## Review 2

The paper is related to the needs of groundwater modeling using exclusively machine learning approaches. Whereas this field of research is not completely new, the use of two specific model architecture (TFT and N-HITS) has never been published in hydrogeology which represents a novelty. In addition, the study combines both static and dynamic features in the dataset. Static features have been carefully selected to represent hydrogeological properties, or representing links with groundwater levels that hydrogeologists can easily figure out.

**BB\_29519013**

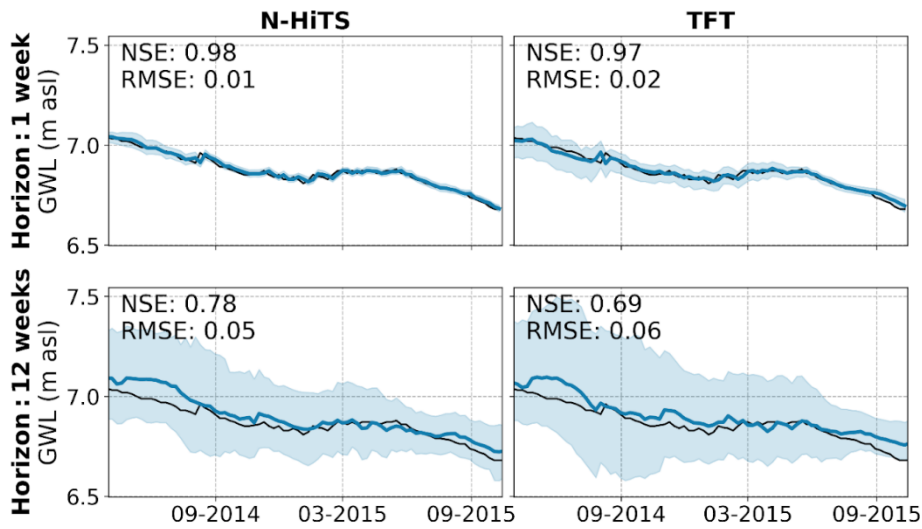
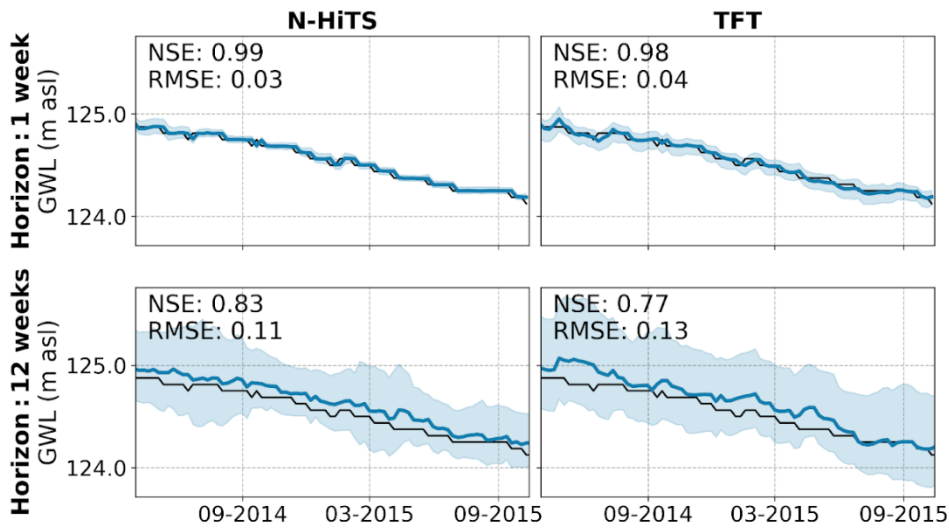
38.1) line : 291 "The single-well models solely used meteorological input features (Temperature and precipitation), while the LSTM approach included static features"

line : 294 "The wells in these studies were preselected on the basis that their groundwater dynamics were primarily influenced by climatic processes [...]"

line 301 "However, N-HITS in its current implementation requires the target feature as input feature, and is for this task inferior to the single-well CNNs or the global LSTM."

and line 274 - "The most important past time steps, according to the attention scores, were often at the beginning of the input sequences (52 weeks, i.e. the week a year ago) and recent time points. " + the feature importance of the 'groundwater level' (figure 6) suggest that the vast majority of wells exhibits an annual regime with very little variations around this. This suggest that TFT of NHiTS are very capable of replicating the past patterns of groundwater heads (low flow in summer, high flow in winter), but not very capable to understand the transformation of rain into groundwater levels evolution (through /infiltration/recharge and possibly delay into the unsaturated zone, and up to the top of aquifer).

While we found that the models perform well for monitoring wells with an expected seasonal pattern, there are also instances where the models effectively capture unusual dynamics, such as hydrographs with a weak seasonality and extended phase of recession or a downward trend. We will include two such examples in Figure B7 to illustrate this and describe these examples in the manuscript. These examples are well BB\_29519013 and ST\_47360014:
